TO: Mercedes-Benz Dealer Principals, General Managers, Sales Managers, Service Managers, Parts Managers	FROM: Gregory Gunther, Senior Manager, Vehicle Compliance and Analysis, Engineering Services
RE: Service Campaign Launch Notification Check Top of Right and Left Fenders at A-Pillar Paneling MY23 CLA (118 platform)	DATE: May 10, 2024

Service Campaign Bulletin

Campaign No. 2024040014, May 2024

Check Top of Right and Left Fenders at A-pillar Paneling

Figure 1

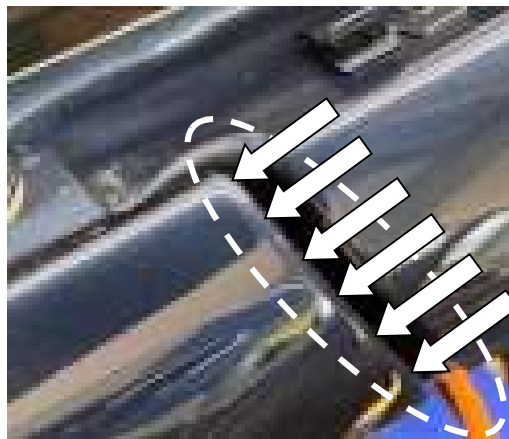
1. Remove drip rail on right and left of windshield.
i For basic data, see **AR88.80-P-4000MFA**.
2. Unscrew screw (**Figure 1, 1**) on right and left side of vehicle.
3. Lift fender above and check A-pillar paneling (**Figure 2, arrows**) for paint damage (cracking/chipping, deformations or rubbing).

Figure 3

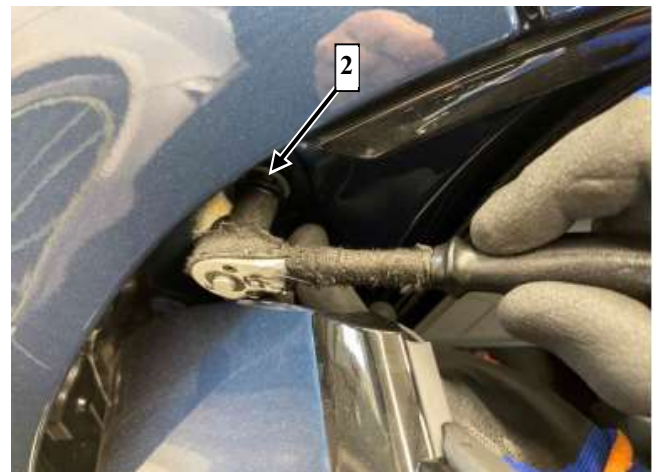
1. Release screw (**Figure 3, 2**) on underside of fender.
i Release top fender to gain better access to the area to be processed. Do not damage adjacent component parts.

Figure 4

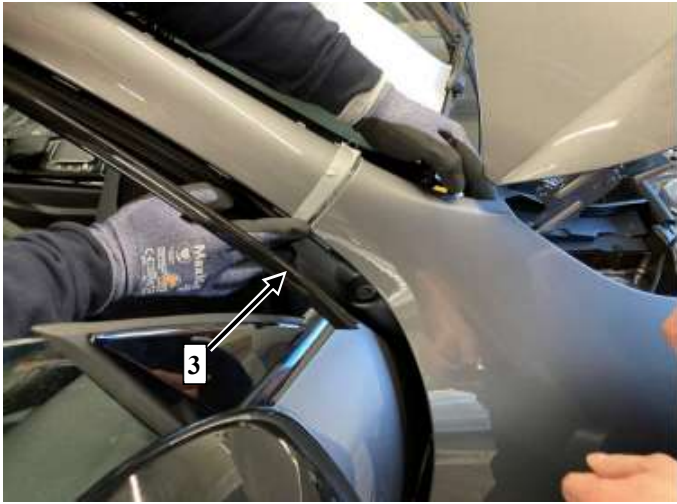
2. Partially release seal and trim bar of door (**Figure 4, 3**) in front area.
